RE: Recommended Amendment to the *Dane County Water Quality Plan*, Revising the Cross Plains Urban Service Area Boundary and Environmental Corridors in the Town of Cross Plains.

**Staff Analysis of Proposed Amendment to the
Dane County Land Use and Transportation Plan and Dane County Water
Quality Plan, Revising the Cross Plains Urban Service Area Boundary and
Environmental Corridors in the Town of Cross Plains**

Map 4 Proposed Land Use

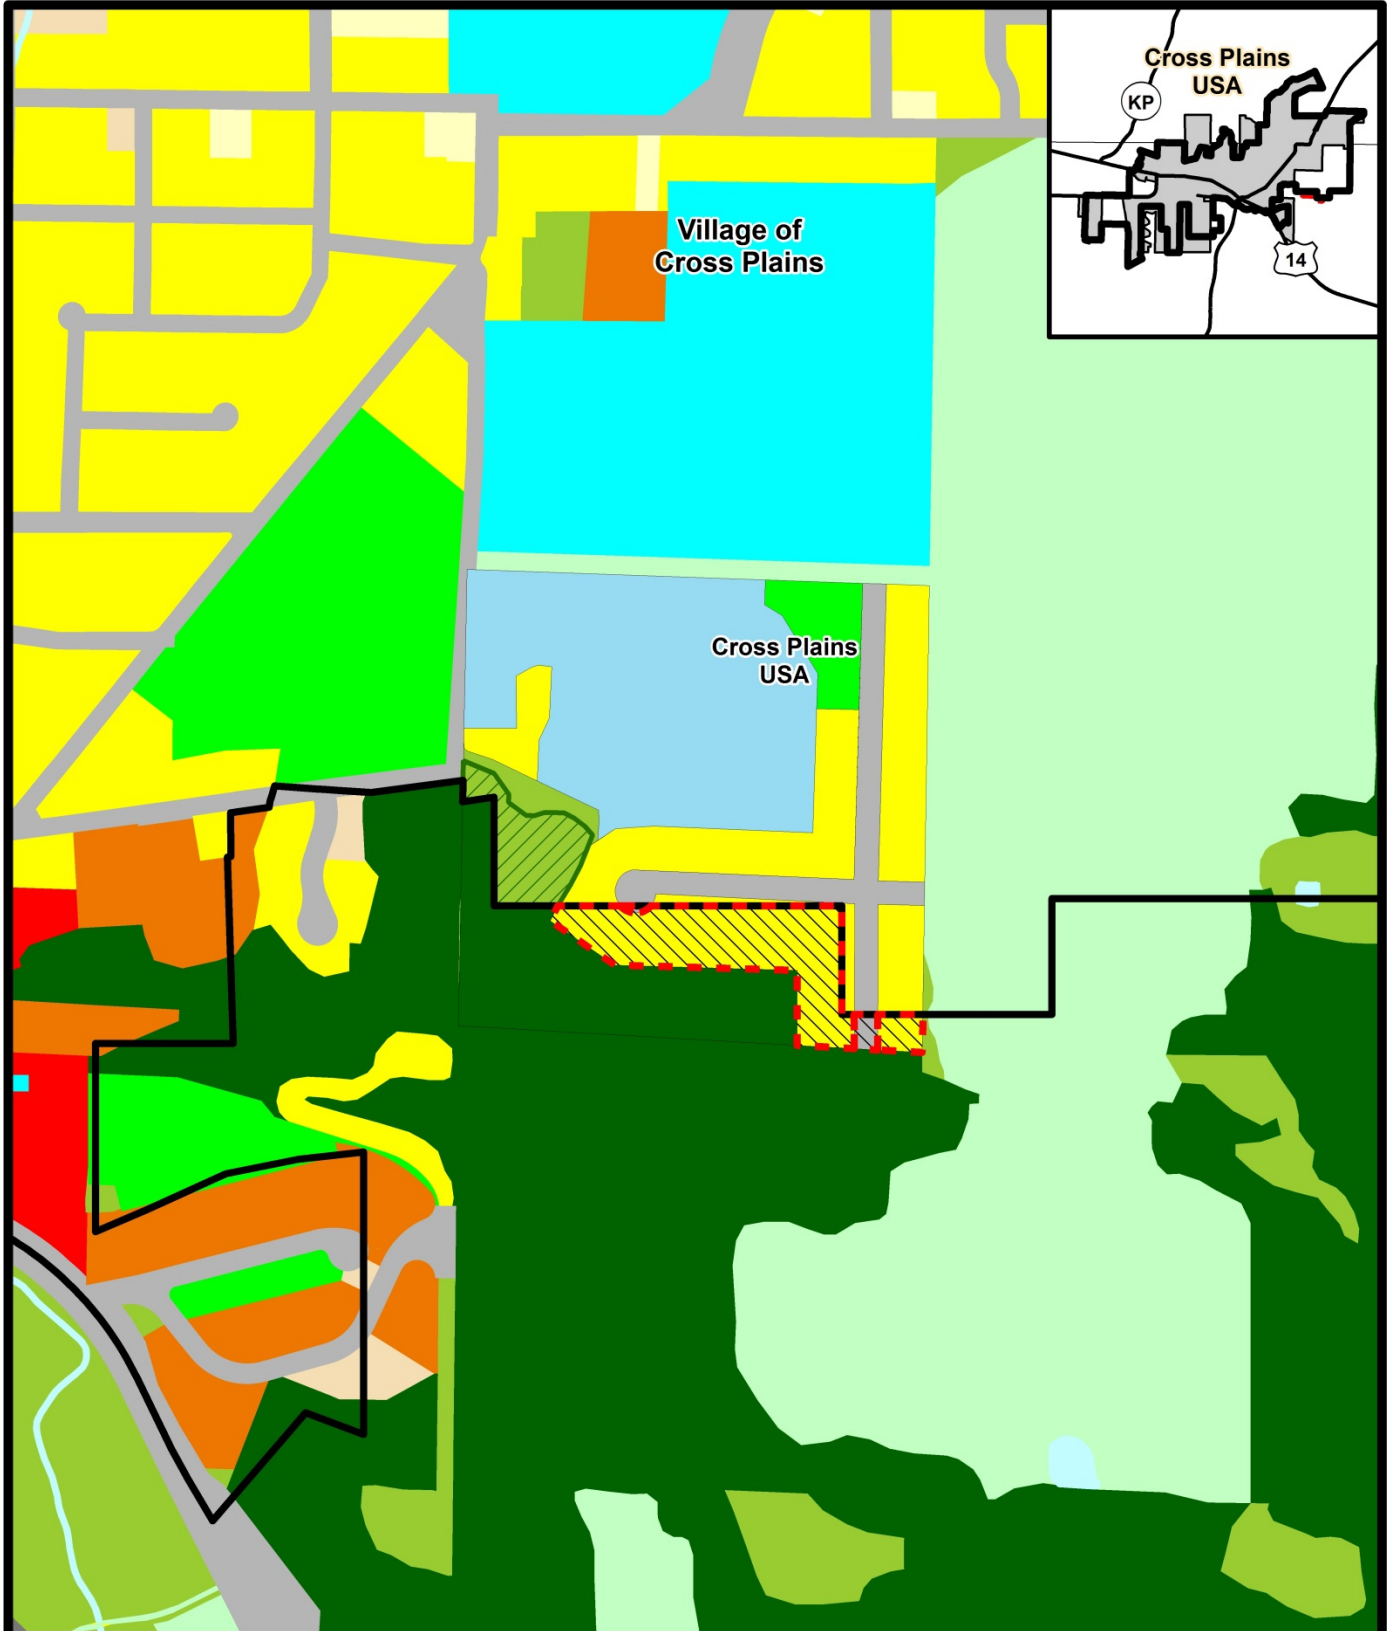
The proposed amendment area does not include any waterbodies, wetlands, hydric soils, or floodplains that are unsuitable for development because of physical or environmental constraints and require preservation in environmental corridors. Approximately 1.8 acres of land in the existing urban service area, which are currently zoned as woodland and/or hillside/hilltop protection areas and conservancy/permanent open space under Village Ordinances, are being added to the environmental corridors as part of this amendment. Stormwater management facilities for the proposed development should also be designated as environmental corridors.

The proposed amendment area does not include any waterbodies, wetlands, hydric soils, or floodplains that are unsuitable for development because of physical or environmental constraints and require preservation in environmental corridors. Approximately 1.8 acres of land in the existing urban service area, which are currently zoned as woodland and/or hillside / hilltop protection areas and conservancy / permanent open space under Village Ordinances, are being added to the environmental corridors as part of this amendment.

Map 9 –Proposed Utilities

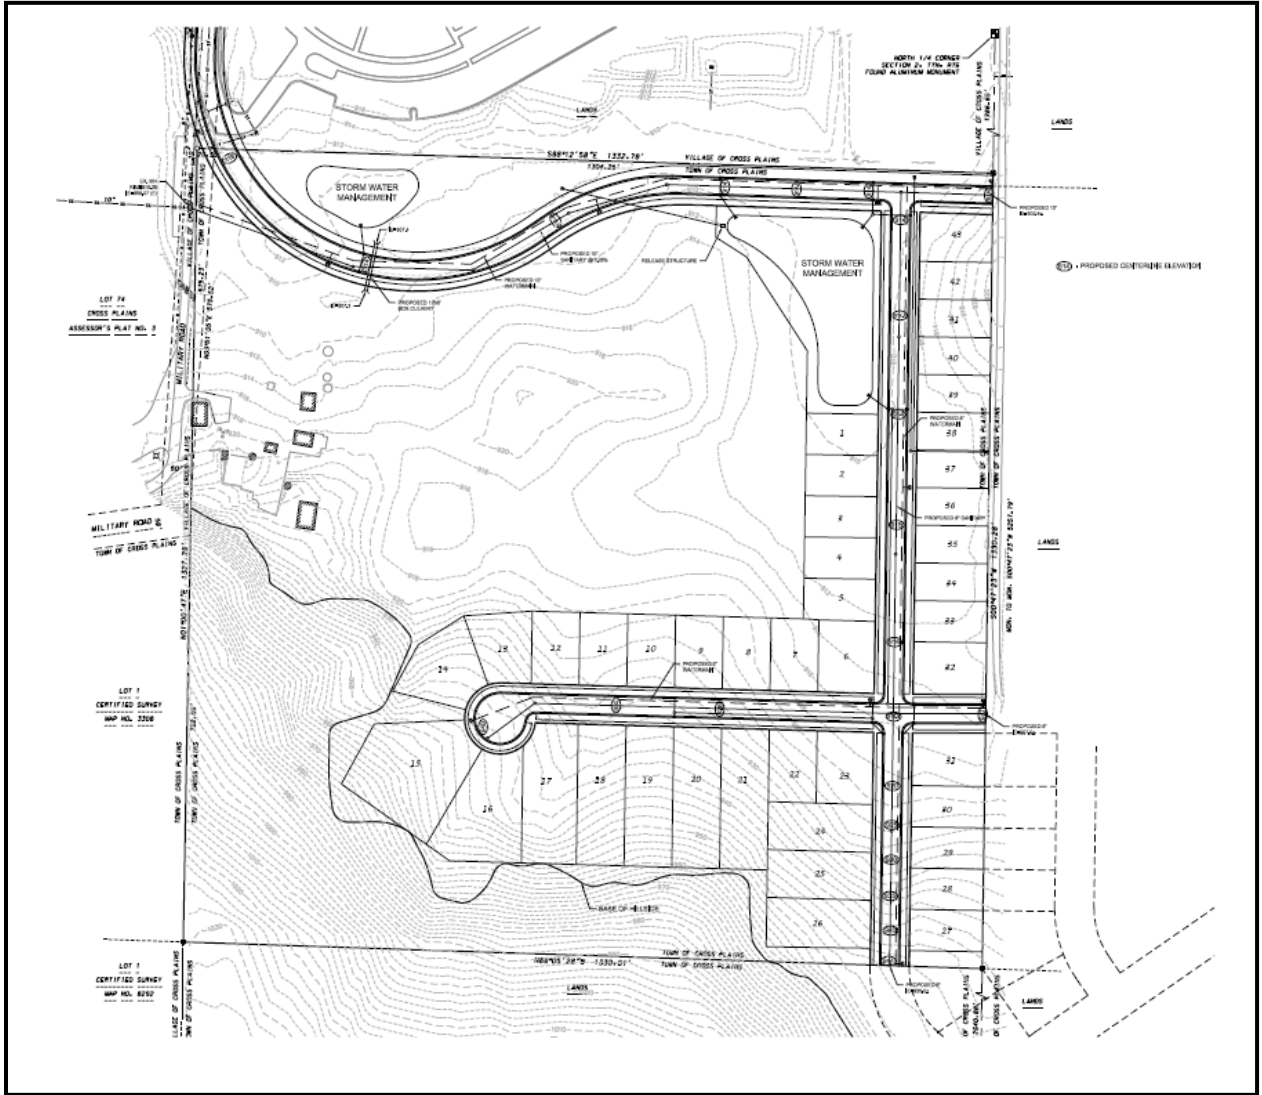
The preliminary location of stormwater management facilities for the development are shown in the proposed development plan (see Map 9).

1. Submit a detailed stormwater management plan for CARPC and DCL&WCD staff review and approval prior to any land disturbing activities in the amendment area. The stormwater management plan should include the following:
 - a. Install stormwater and erosion control practices prior to other land disturbing activities. Protect infiltration practices from compaction and sedimentation during land disturbing activities.
 - b. Control peak rates of runoff for the 1-, 2-, 10-, and 100-year 24-hour design storms to pre-development levels, using the updated precipitation depth and storm distribution (NRCS MSE4) data developed through the National Oceanic and Atmospheric Administration Atlas 14 project, in accordance with the Dane County Stormwater Ordinance.
